E8803A-01C S E R V I C E N O T E

Supersedes: E8803A-01B

E8803A PNA Series RF Network Analyzers

Serial Numbers: 00000000 thru 46999999

Figure 1

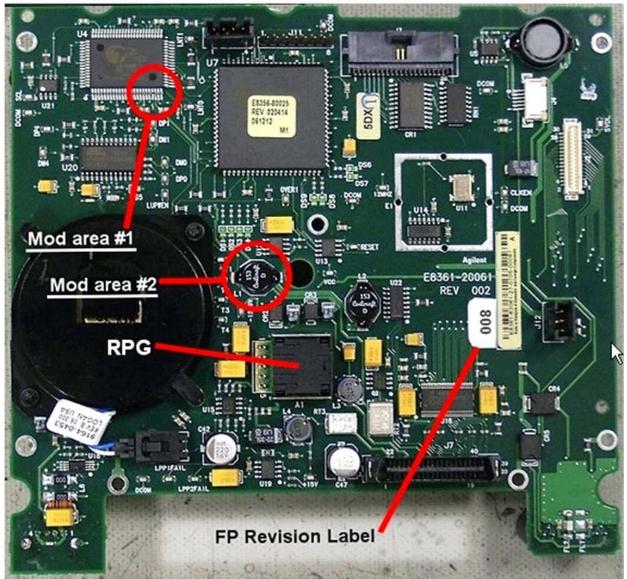
Refer to Figure 1 for the two modification areas to be addressed. Note that while this picture happens to show the FPI board completely removed from the front frame assembly, this is not necessary to perform the required modifications.

- Modification #1 consists of shorting two pins of U4 together with a small amount of solder.
- Modification #2 consist of removing L1.

Figure 2

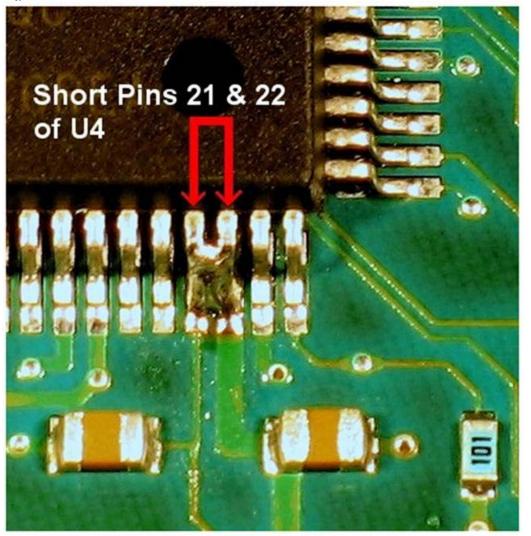
Carefully solder pins 21 and 22 together on U4. Refer to Figure 2 for the exact location. Use care so that no other pins are shorted. Use of a very fine tip soldering iron is recommended and a large work-task magnifying glass is very helpful.
